Authorized Field Change

AFC G-05914

Subject: Transmission Shift Cable Exposure to the Exhaust Manifold in CF 500 and CF 600 Models Built Between January 1, 2005 and July 14, 2005

Figure 4 Install (Slide) Heat Shield onto Shift Cable

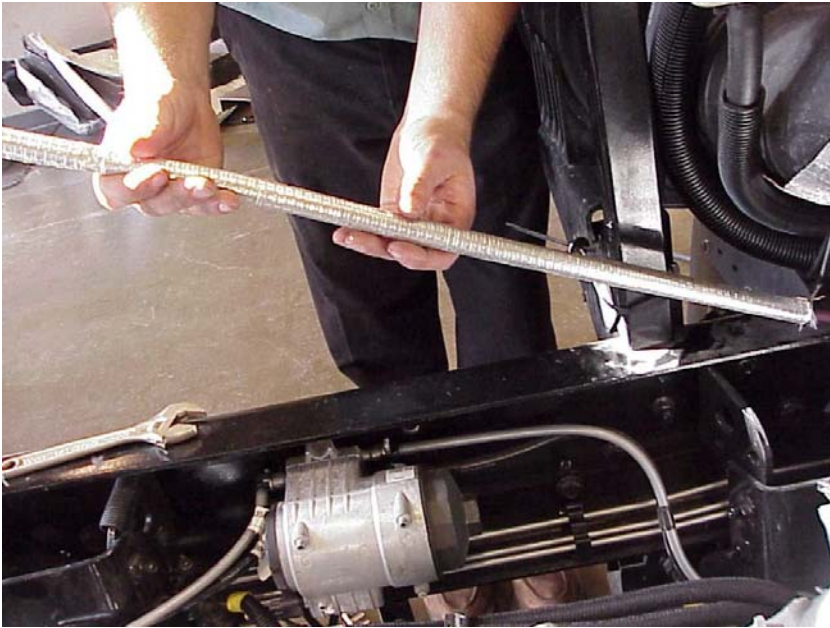
6. Mark the position of the adjuster jam nut on the shift cable (Figure 5, Item 2) and remove the adjuster (Figure 5, Item 3) from the end of the shift cable.
7. Install (slide) heat shield, Part Number 3565208R1, onto the shift cable (Figure 4) until the adjuster end of the shift cable is as shown in Figure 5. Install a cable lock strap, Part Number 289862C1, at each end of the heat shield.
